REV.
B

AS9554

SCREW, MACHINE - DOUBLE HEXAGON EXTENDED WASHER HEAD, CORROSION AND HEAT RESISTANT STEEL, UNS S66286, 130 KSI MIN, .1380-40 UNJF-3A

ISSUED 2000-08 REVISED 2006-05

FIGURE 1 - SCREW

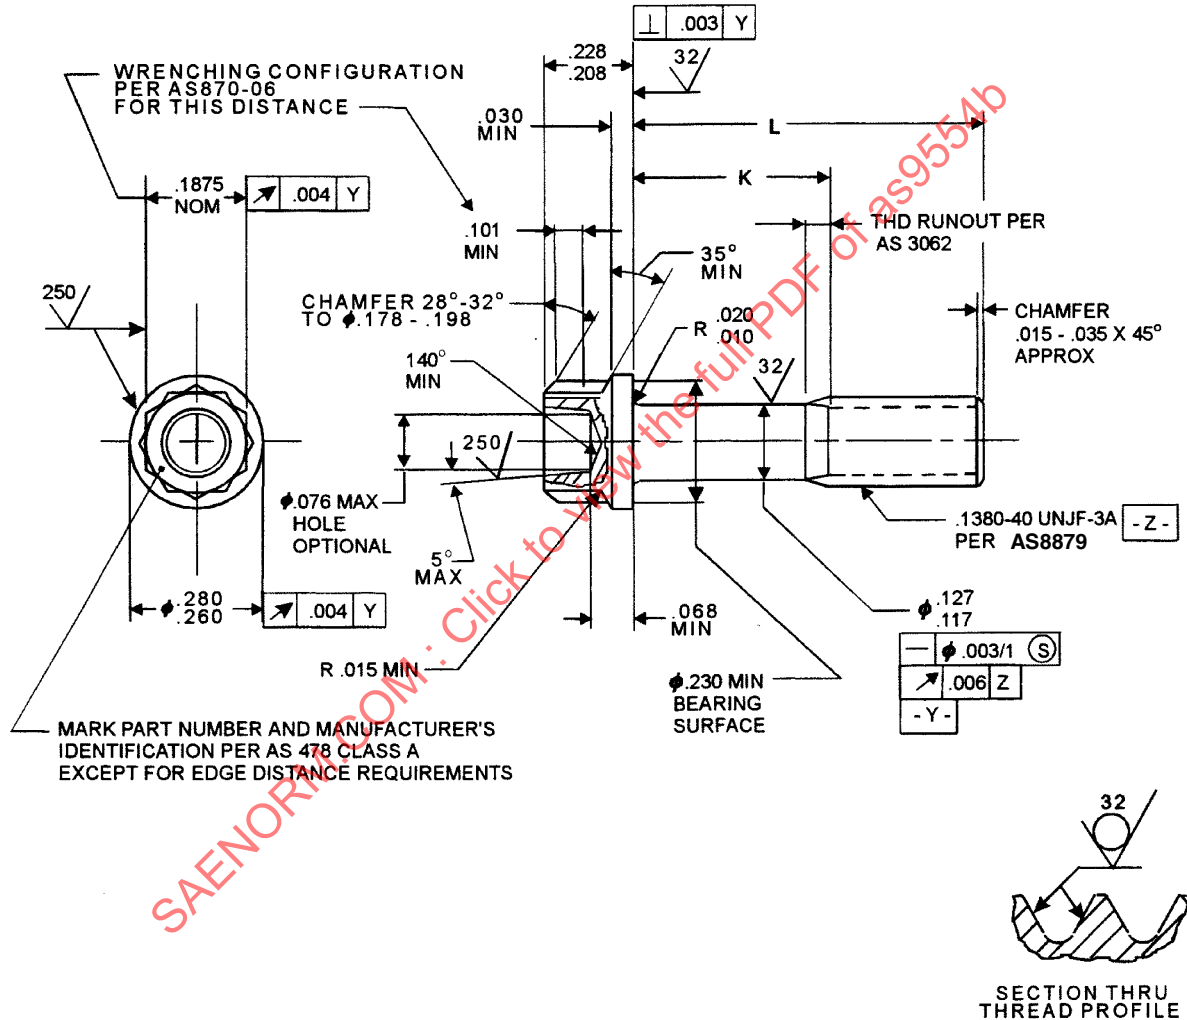
ADD DATUM REQUIREMENTS FOR -.02 THRU -.10 LENGTHS (NEW NOTE 1) AND REVISE THREAD SPEC TO AS8879.
